V2500-A5 SERIES SERIES PROPULSION SERVICE BULLETIN

This document transmits Revision 4 to Service Bulletin NV2500-71-0273

V2500-NAC-71-0273

NACELLE – ENGINE BUILD UNIT (EBU) – REPLACEMENT AND REROUTING OF SEVERAL EBU SYSTEMS
TO ACCOMMODATE THE REROUTING OF THE OIL SCAVENGE TUBES

Removal of the Cabin Air Tube
Figure 1

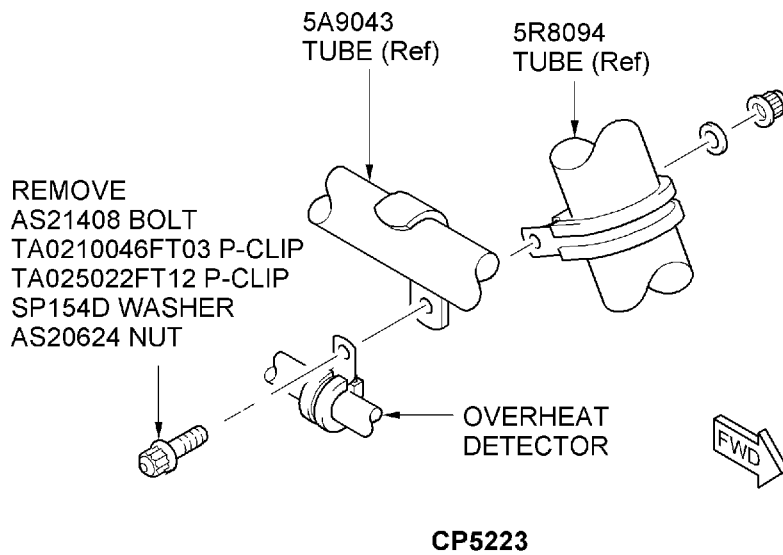
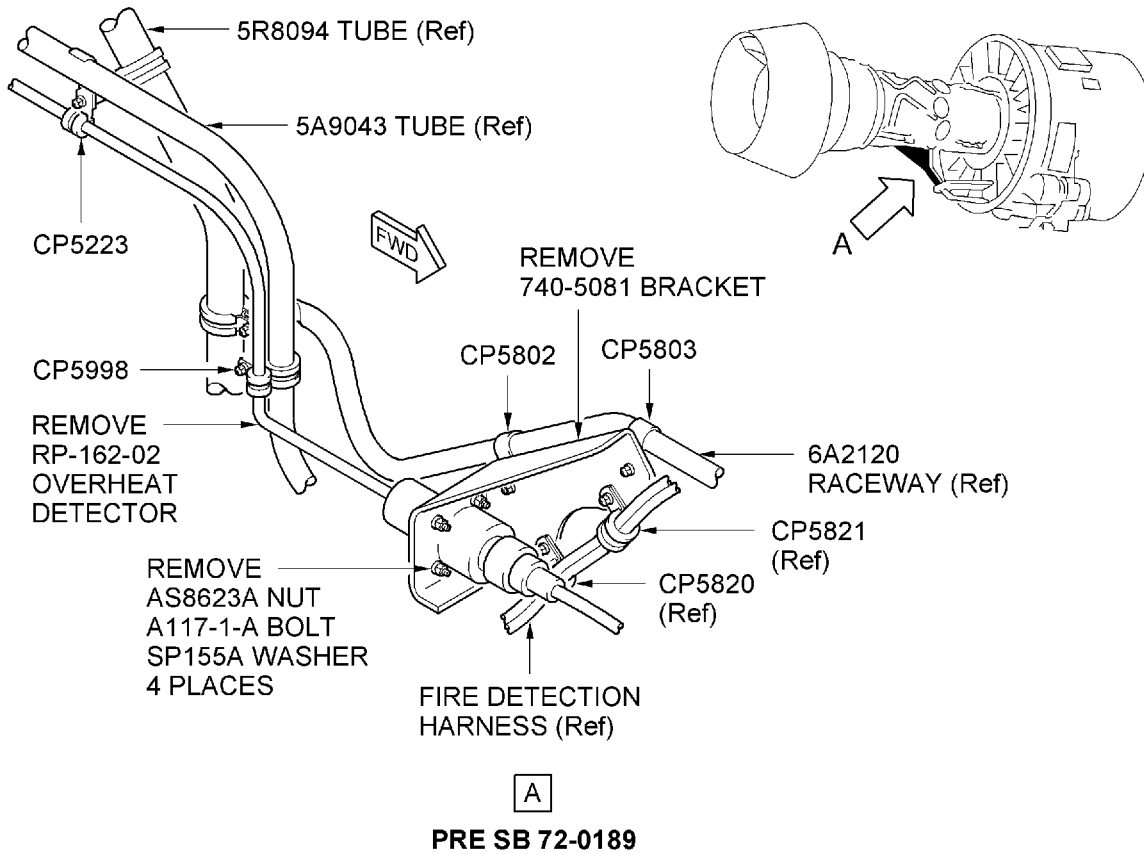
- (3) Remove the 740-5089-501 Cabin Air Tube.

- (a) Clipping Point CP5862 – Remove the AS21406 Bolt, the AS41104 Clip Nut and the TA025022FT04 P-Clip. Refer to Figure 1.
- (b) Cut and safety the Lockwire which safeties the Tube Connections.
- (c) Disconnect the 6A5391 Tube from the 740-5089-501 Cabin Air Tube. When you remove the Cabin Air Tube from the Nacelle put the applicable covers/ caps/plugs on to the vacant Engine components.
- (d) Disconnect the 740-5089-501 Cabin Air Tube from the 740-5644 Tube.
- (e) Disconnect the 740-5089-501 Cabin Air Tube from the High Pressure Bleed Valve.
- (f) Remove the 740-5089-501 Cabin Air Tube from the Nacelle.
- (4) Remove the 7702-02 Fire Detector.

Removal of the Overheat Detector and Bracket
Figure 2, Sheet 1 of 2

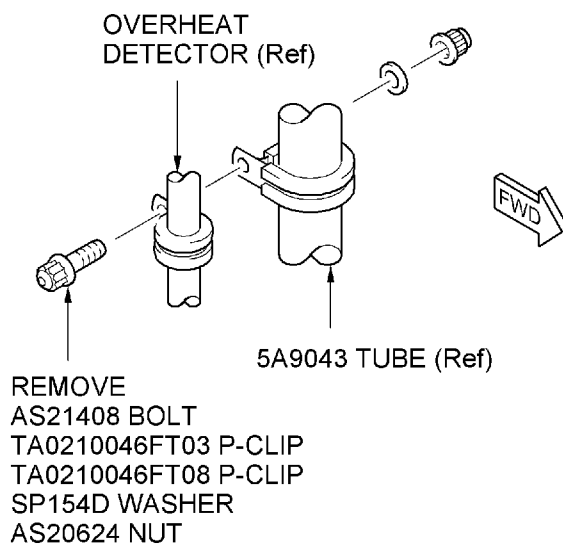
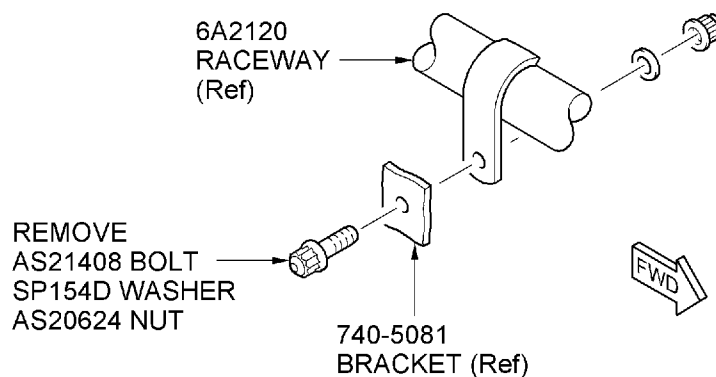
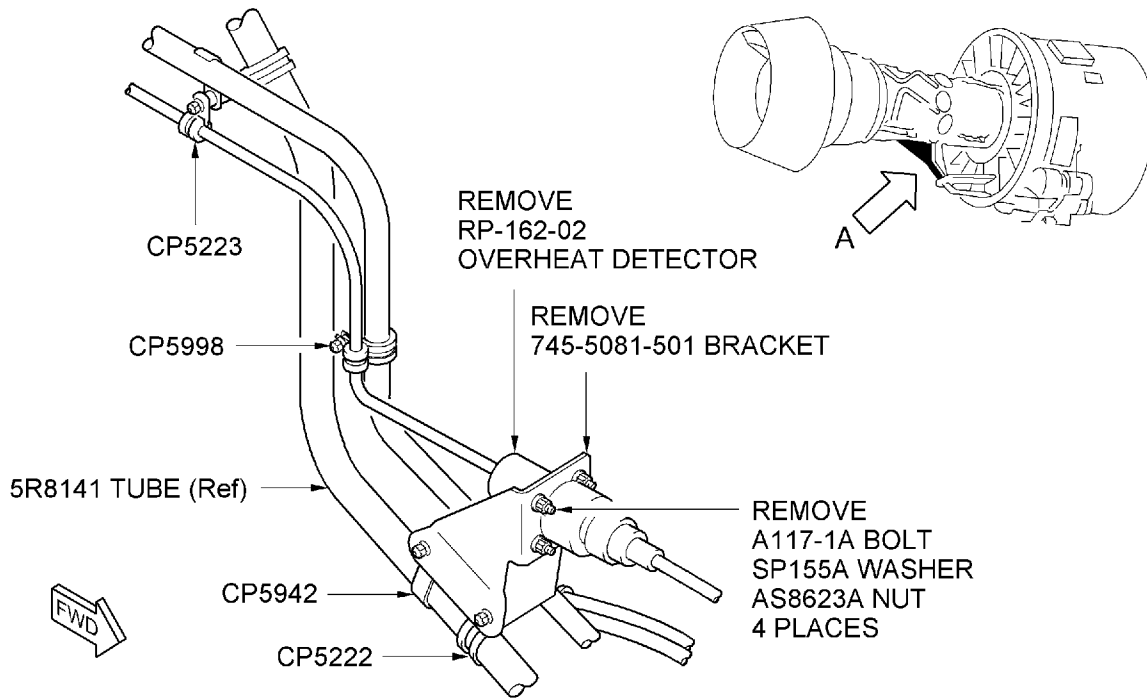
- (6) Remove the RP162-02 Overheat Detector.

| <p>(a) Clipping Point CP5223 - Remove the AS20624 Nut, the SP154D Washer, AS21408 Bolt, the TA0210046FT03 P-Clip and the TA025022FT12 P-Clip.</p> <p>(b) Clipping Point CP5998 - Remove the AS20624 Nut, the SP154D Washer, the AS21408 Bolt, the TA0210046FT03 P-Clip and the TA0210046FT08 P-Clip.</p> <p>(c) Remove the four AS8623A Nuts, the four SP155A Washers and the four A117-1-A Bolts to release the RP162-02 Overheat Detector from the 740-5081 Bracket.</p> <p>(d) Remove the RP162-02 Overheat Detector from the Nacelle and retain.</p> | <p>Refer to Figure 2.</p> |

- (7) Remove the 740-5081 Overheat Detector Bracket.

| <p>(a) Clipping Points CP5802 and CP5803 - Remove the AS20624 Nut, the SP154D Washer and the AS21408 Bolt to release the 740-5081 Bracket from the 6A2120 Raceway.</p> <p>(b) Remove the 740-5081 Overheat Detector Bracket from the Nacelle.</p> | <p>Refer to Figure 2.</p> |

Removal of the Overheat Detector and Bracket
Figure 3, Sheet 1 of 2

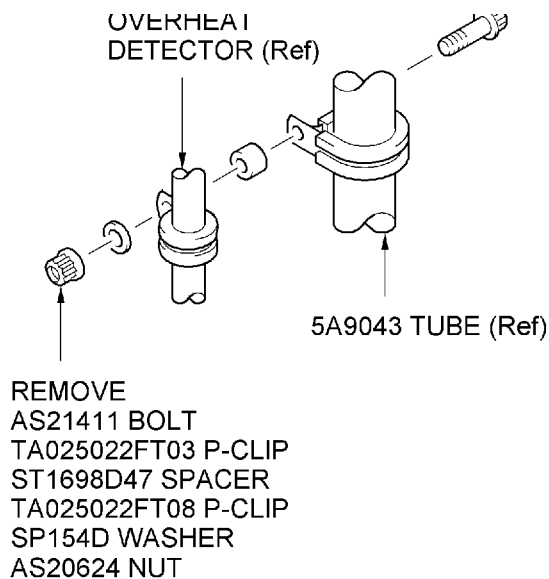
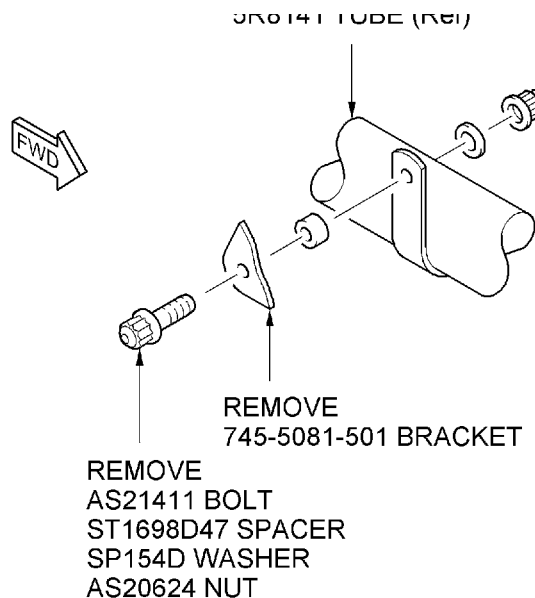
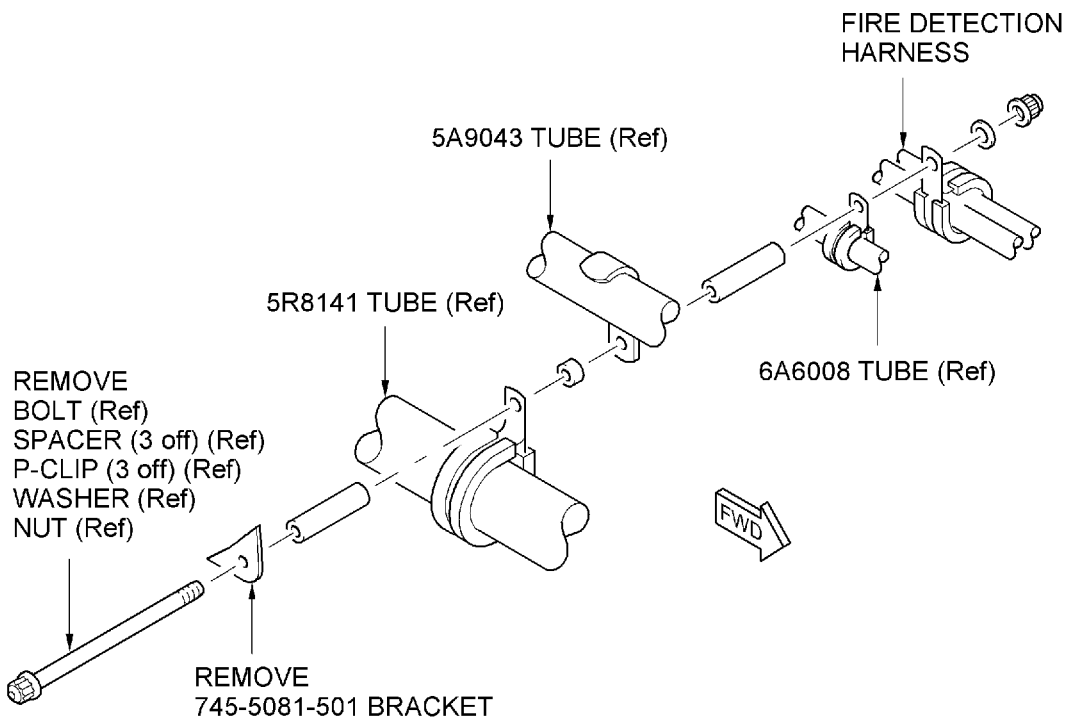
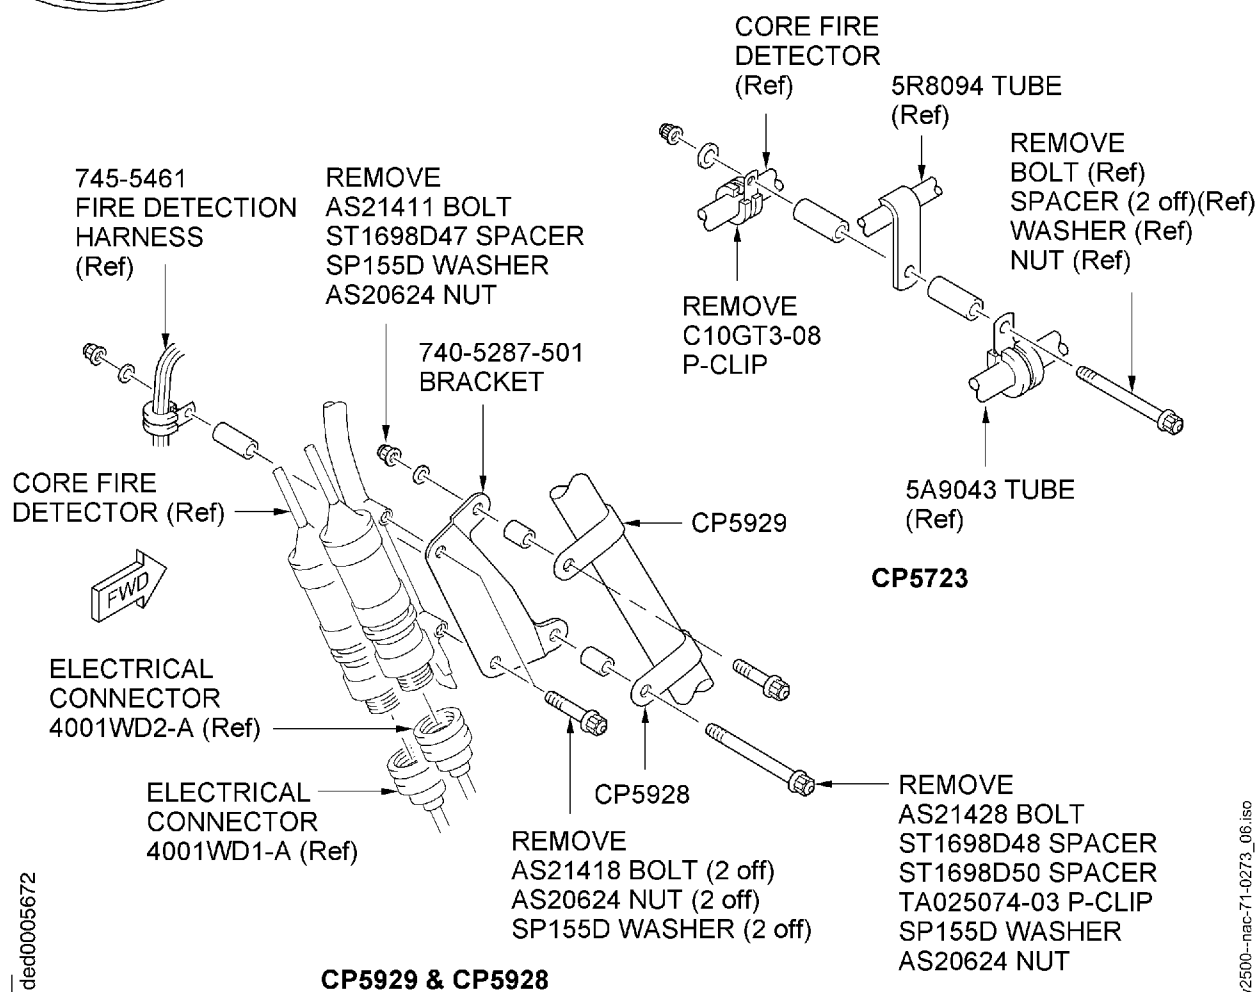
- (5) Remove the RP162-02 Overheat Detector.

| (a) CP5223 - Remove the AS20624 Nut, the SP154D Washer, AS21412 Bolt, the ST1698D47 Spacer, the TA025022FT03 P-Clip and the TA025022FT12 P-Clip. | Refer to Figure 3. |
| (b) CP5998 - Remove the AS20624 Nut, the SP154D Washer, the AS21411 Bolt, the ST1698D47 Spacer, the TA025022FT03 P-clip and the TA025022FT08 P-Clip. | |
| (c) Remove the four AS8623A Nuts, the four SP155A Washers and the four A117-1-A Bolts to release the RP162-02 Overheat Detector from the 745-5081-501 Bracket. | |

- (6) Remove the 745-5081-501 Overheat Detector Bracket.

- (a) CP5942 – Remove the AS20624 Nut, the SP154D Washer, the AS21411 Bolt and the ST1698D47 Spacer to release the 745-5081-501 Bracket from the 5R8141 Tube.
- (b) CP5222 – Release the 745-5081-501 Bracket from the 5R8141 Tube.
- (c) Remove the 745-5081-501 Overheat Detector Bracket from the Nacelle.
- (7) Remove the 740-5287-501 Fire Detector Bracket.

Figure 4

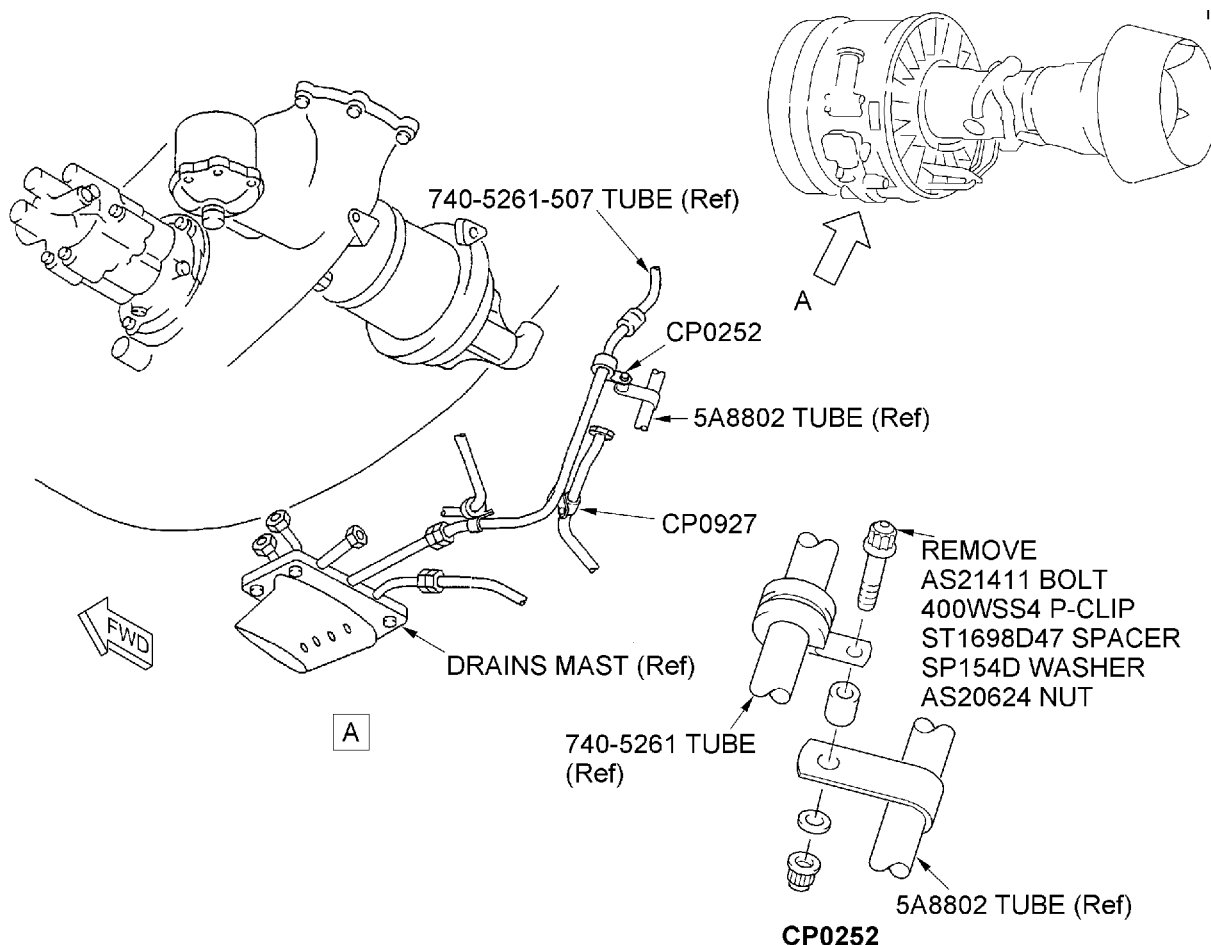
- (8) Remove the 740-5287-501 Fire Detector Bracket.

- (a) Remove the two AS20624 Nuts, the two SP155D Washers and the two AS21418 Bolts to release the Fire Detector Responders from the 740-5287-501 Fire Detector Bracket. Retain the Bolts and Washers. Refer to Figure 4.

- (b) Clipping Point CP5928 – Remove the AS20624 Nut, the SP155D Washer, the ST1698D48 Spacer, the ST1698D50 Spacer, the AS21428 Bolt and the TA025074-03 P-Clip.

- (c) Clipping Point CP5929 – Remove the AS20624 Nut, the SP155D Washer, the ST1698D47 Spacer and the AS21411 Bolt to release the 740-5287-501 Bracket from the 6A5367 Pipe.

- (d) Remove the 740-5287-501 Bracket from the Nacelle.
- (9) At Clipping Point CP5723 remove the C10GT3-08 P-Clip. Refer to Figure 4.
- NOTE:** The instructions for the removal of Clipping Points CP0252 and CP0927 may be for reference only. Clipping Points may be removed as part of Service Bulletin V2500-ENG-79-0088.

- (8) At Clipping Point CP5723 remove the C10GT3-08 P-Clip. Refer to Figure 4.

Disassembly of Clipping Points CP0252 and CP0927
Figure 5

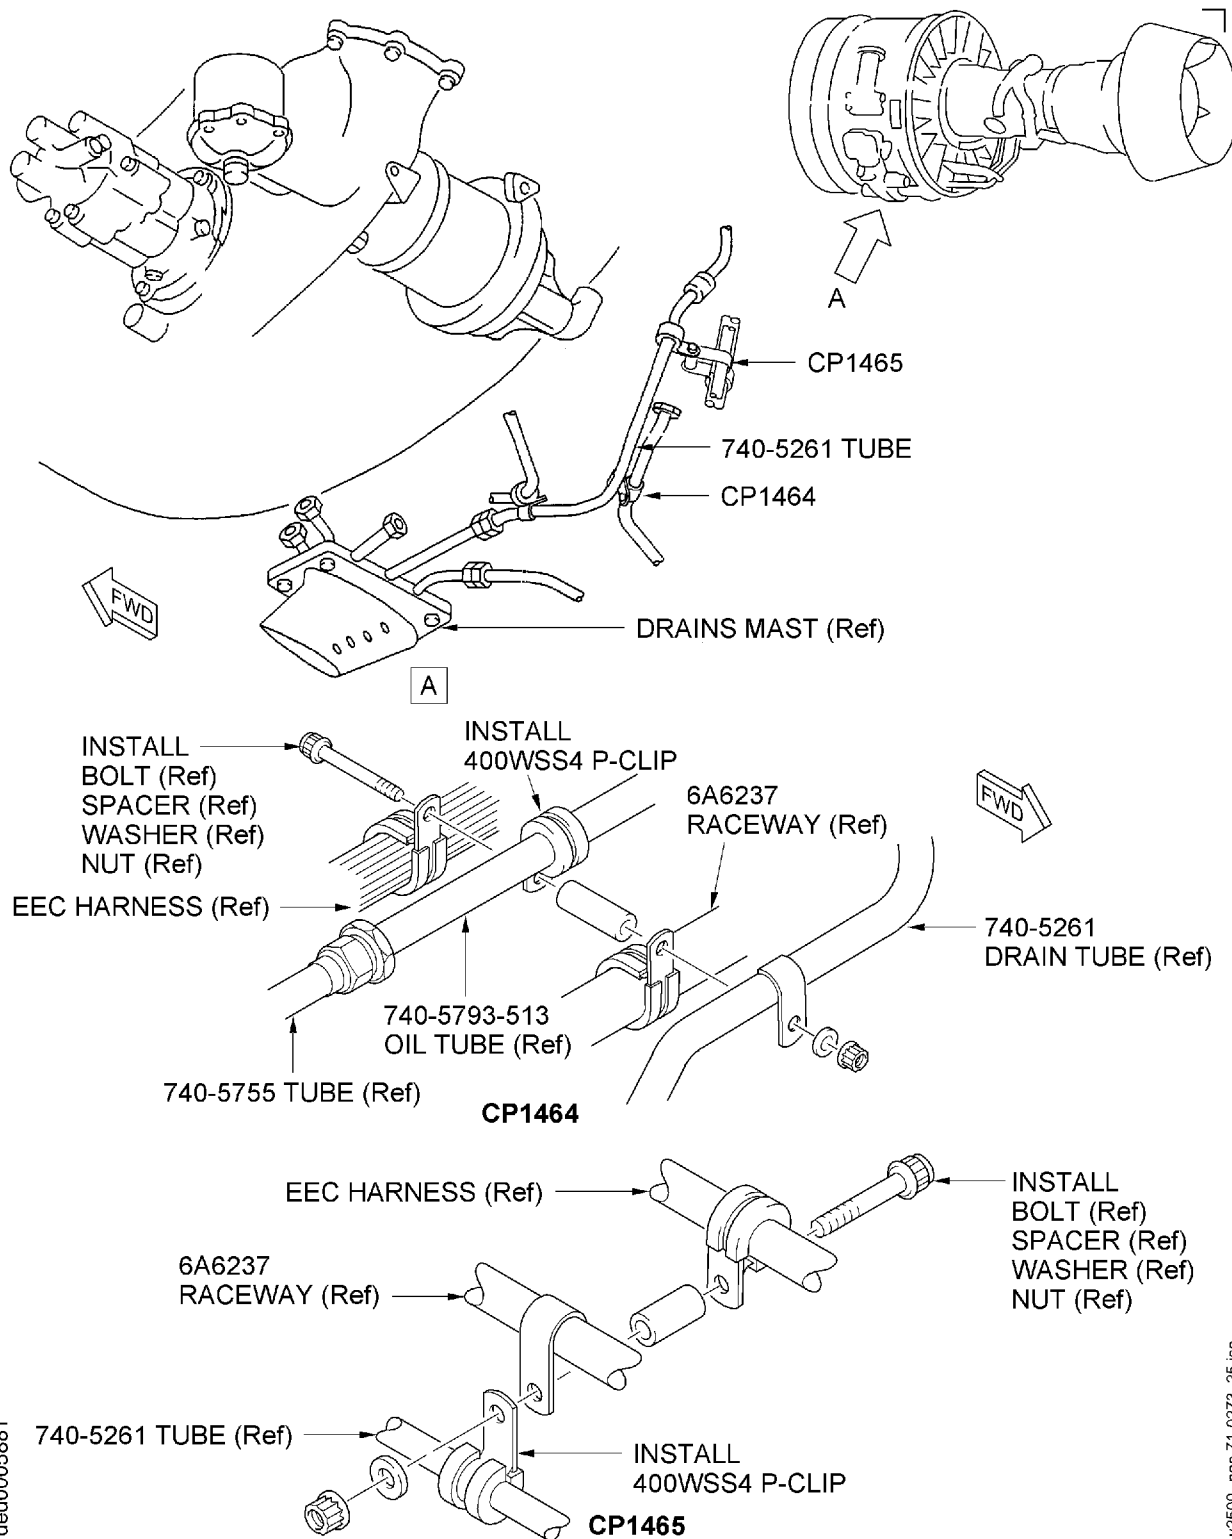
- (10) At Clipping Point CP0252, remove the AS20624 Nut, the SP154D Washer, the ST1698D47 Spacer, the AS21411 Bolt and the 400WSS4 P-Clip from the 740-5261 Drain Tube. Refer to Figure 5.

- (11) At Clipping Point CP0927, remove the AS20624 Nut, the SP154D Washer, the ST1698D47 Spacer, the AS21411 Bolt and the 400WSS4 P-Clip.
- NOTE:** The instructions for the installation of Clipping Points CP1465 and CP1464 may be for reference only. Hardware for Clipping Points are kitted and may be installed as part of Service Bulletin V2500-ENG-79-0088.

- (9) At Clipping Point CP0252, remove the AS20624 Nut, the SP154D Washer, the ST1698D47 Spacer, the AS21411 Bolt and the 400WSS4 P-Clip from the 740-5261 Drain Tube. Refer to Figure 5.

- (10) At Clipping Point CP0927, remove the AS20624 Nut, the SP154D Washer, the ST1698D48 Spacer, the AS21414 Bolt and the 400WSS4 P-Clip.
